SERVICE BULLETIN

POWER PLANT - NACELLE - POWERPLANT - FAN COWL DOOR (LH); HOLD OPEN ROD STOWAGE BRACKET
- TO RE-POSITION - CATEGORY CODE 4 - MOD.NAC-71-0096

V2500-NAC-71-0096

REMOVAL AND INSTALLATION OF THE STOWING BRACKET
Fig.1

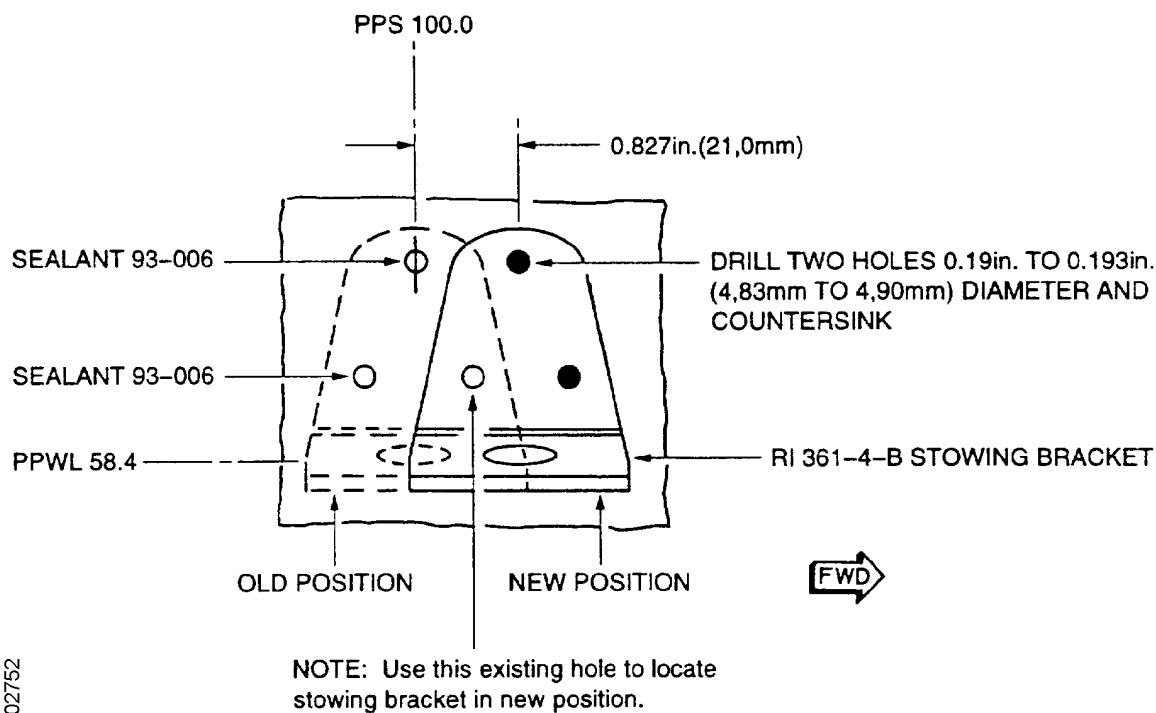
The stowing bracket for the aft hold-open rod on the LH fan cowl door is removed. It is moved over (horizontally) one hole pitch so that the bracket picks up on one of its existing holes (see Figure 1). Two new bolt holes are drilled in the fan cowl door and the stowing bracket then bolted in its new position. The two vacated bolt holes are sealed with a filler and the paint finish then restored.

- (1) Remove three NAS8703U17 bolts, three MS20500 locknuts and three AN960-C10 washers to release the RI.361-4-B stowing bracket. Remove the stowing bracket from the door (Refer to Figure 1).
- (2) Remove any sealant from the mating faces of the RI.361-4-B stowing bracket and the fan cowl door.
- (3) Install the RI.361-4-B stowing bracket back to the fan cowl door (temporarily) in its new position. Refer to Figure 2.

NEW LOCATION OF THE LEFT FAN COWL DOOR HOLD-OPEN ROD
Fig.2

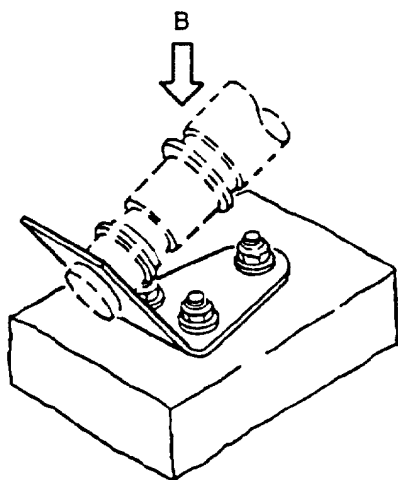
- (4) Drill two holes, .190/.193in (4.83/4.90mm) diameter through the fan cowl door, from the stowing bracket and remove all burrs.
- (5) Countersink the external surface of the fan cowl door (for the installation of two NAS8703U17 bolts) 100 deg by .049in deep.

- (7) Apply PL32M jointing compound to the mating face of the RI.361-4-B stowing bracket and install it in its new position.
- (8) Wet install with PL32M jointing compound: three NAS8703U17 bolts, three MS20500 locknuts and three AN960-C10 washers. Torque the nuts to 40 lbf in (4.52 Nm).
